## Silver Spring Retirement Residence, Preliminary Plan Amendment No. 12016020A

### Description

Request to modify condition no. 9 to allow an additional year to coordinate with the State Highway Administration regarding the shared use path; reflect revised/approved stormwater management easements and utilities; construct an additional retaining wall; and revise the landscape and lighting plans.

Figure 2: Preliminary Plan Amendment

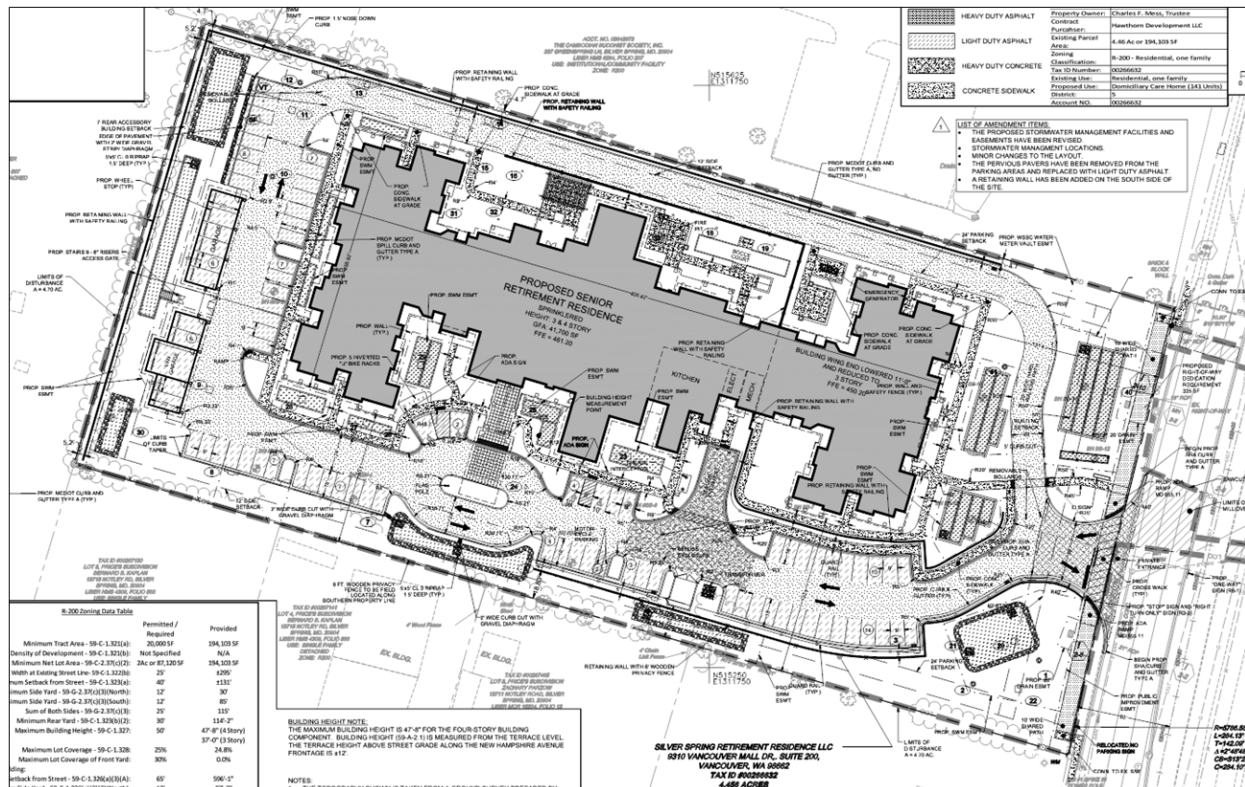
- Modify condition #9, allowing an additional year for the Applicant to coordinate with the State Highway Administration (SHA) regarding the abandonment of the drainage easement located along the frontage of New Hampshire Avenue, the recordation of a Public Improvement Easement (PIE) for portions of the proposed shared use path that are outside of the right-of-way, and the construction of the shared use path, as shown on the Preliminary Plan. The additional year is necessary due to the final design and easement agreements with SHA.

- Revise the stormwater management easements to reflect the Revised Stormwater Management Plan approved by the Department of Permitting Services on July 17, 2017 (Attachment 2).

- Revise the location of wet and dry utilities to accommodate revised storm drain and sewer location.
- Add a retaining wall (variable height up to 7 feet tall) around the southeast corner of the parking lot to accommodate additional stormwater management facilities.

- Revise landscape and lighting plans based on the changes to the stormwater management easements. Revisions include: relocation of light fixtures; new landscape treatment along the proposed retaining wall; relocation of six (6) mitigation trees to be outside the revised storm water management easement areas; and removal/replacement of select trees where site

conditions (e.g. constrained, narrow planting widths) do not support the long-term viability of these trees.

Staff recommends approval of Preliminary Plan Amendment 12016020A to modify condition no. 9, allowing an additional year to coordinate with SHA regarding the shared use path; reflect revised/approved stormwater management easements and utilities; construct an additional retaining wall; and to revise the landscape and lighting plans. All site development elements shown on the latest electronic version of Preliminary Plan Amendment No. 12016020A submitted via ePlans as of the date of this staff report are required. All previous approved plans, findings, and conditions of approval remain in full force and effect, except as modified herein:

9. Within ~~two~~ three years of approval of the resolution for Preliminary Plan No. 120160200, the Applicant must:
  - a. Obtain approval from the Maryland Board of Public Works to abandon/vacate the SHA drainage easement located along the frontage of New Hampshire Avenue;
  - b. Record in the Land Records a Public Improvement Easement (PIE), in a form approved by the County and/or Maryland State Highway Administration (SHA), for any portion of the shared use path which lies outside of the right of way for New Hampshire Avenue; and
  - c. Construct the shared use path as shown on the Preliminary Plan.
